Memorandum

TO: Karl Benedict, NHDES
FROM: Chris Fournier, PE, HEB Engineers, Inc.
Andrew O'Sullivan, New Hampshire Department of Transportation
SUBJECT: Response to Request for More Information
NHDES File Number: 2020-01554
Columbia-Colebrook, 42313 – NH Route 3 over Simms Stream
Wetlands Permit Application

The purpose of this memorandum is to provide responses to the five (5) NHDES comments in narrative and plan/figure formats (see attachments). The *request language* has been included and the comments have been numbered according to the Request for More Information (RFMI) dated August 7, 2020 with responses for each below.

STATE OF NEW HAMPSHIRE				
DEPARTMENT OF TRANSPORTATION • BUREAU OF HIGHWAY DESIGN				
WETLAND IMPACT PLAN COLUMBIA				
SHEET SCALE	DGN	STATE PROJECT NO.	SHEET NO.	TOTAL SHEETS
1" = 20'	42313WetPlans	42313	5	8

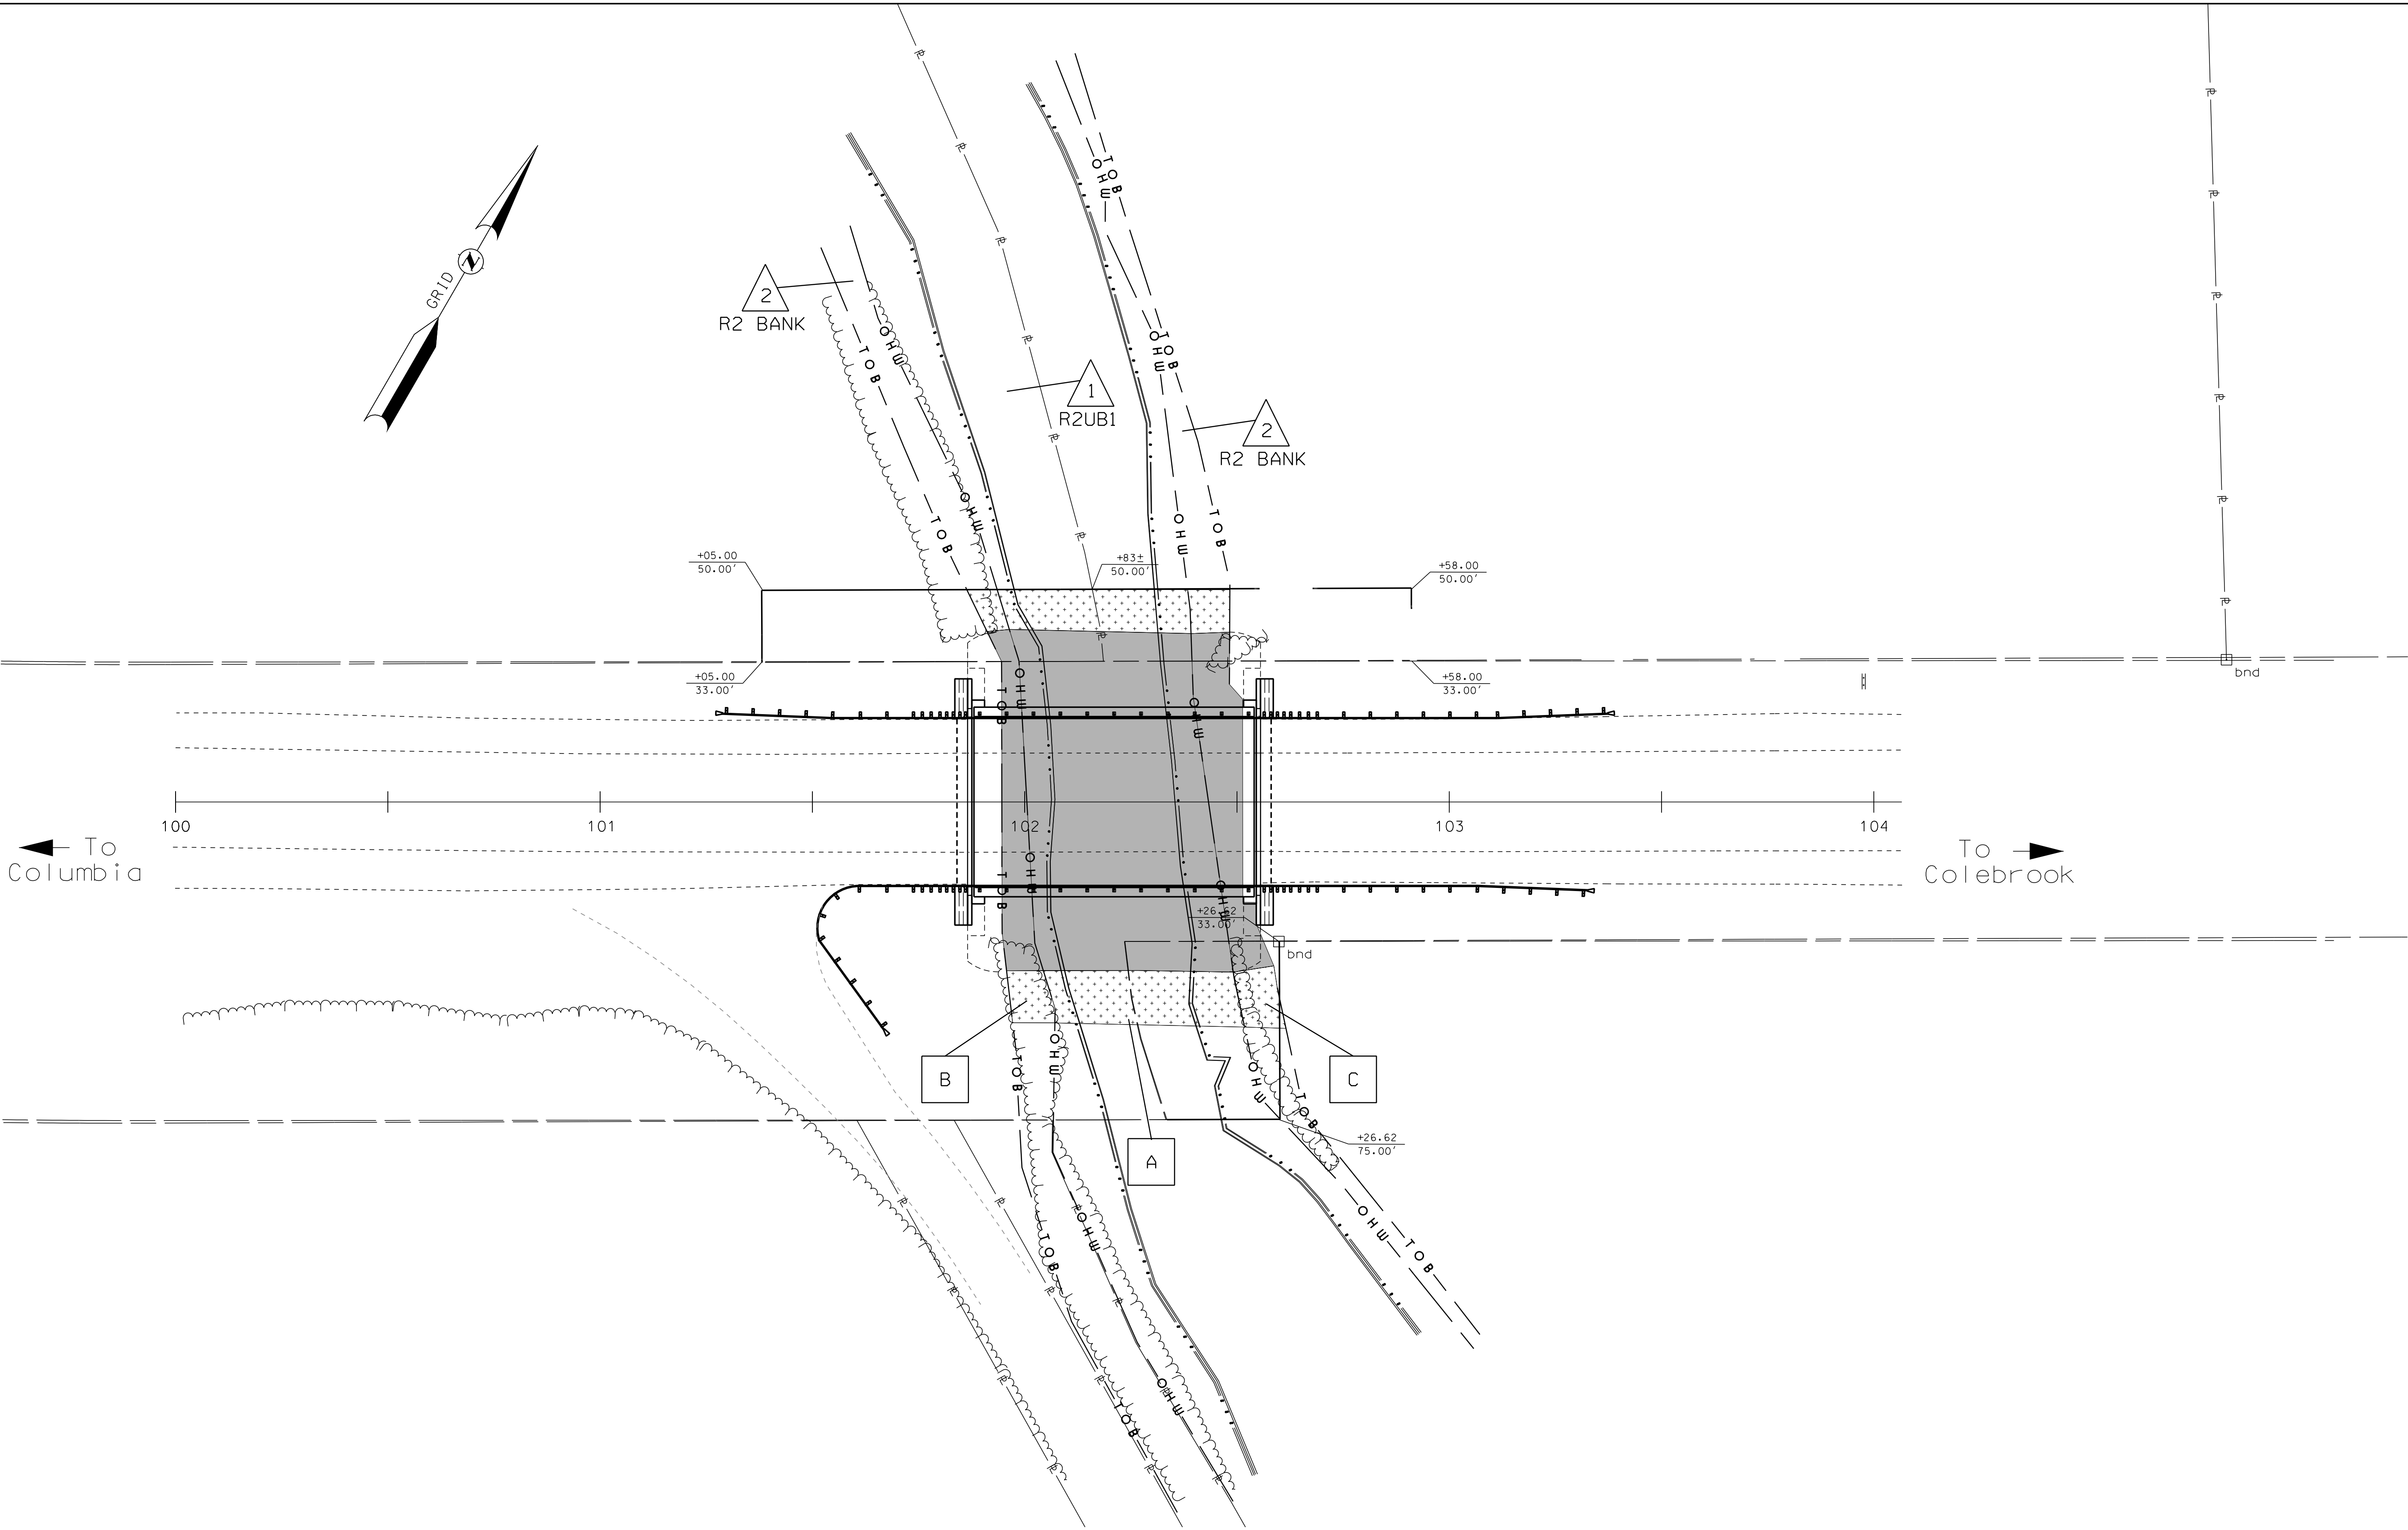
1. NHDES Comment: *Env-Wt 311.04 Application Information. (g) The square feet of wetland impact areas and the linear feet of surface water impact areas for both temporary and permanent impacts based on type of jurisdiction area, including the following: (6) Perennial stream or river; and (7) Stream bank. Proposed impacts located within the bed of river should be distinguished from the proposed impacts located within the 'bank' jurisdiction. Please quantify the square feet and linear feet of permanent and temporary impacts located within each resource area (bed or bank). Impact areas above ordinary high water (OHW) and below Top of Bank (TOB) should be quantified as bank, and areas below OHW should be quantified as perennial stream bed on Wetland Permit Application Page 5 of 9, Section 12-Impact Area and associated plan sheet.*

Response: Impact calculations have been revised in the Wetland Permit Application Page 5 of 9, Section 12 and the associated plan sheet(s) to distinguish between channel impacts (below OHW) and stream bank impact areas (areas below TOB and above OHW). These areas have been classified as R2UB1 and R2 Bank, respectively. Please find a revised plan set, with updated sheets four and five, in Attachment A; and a revised
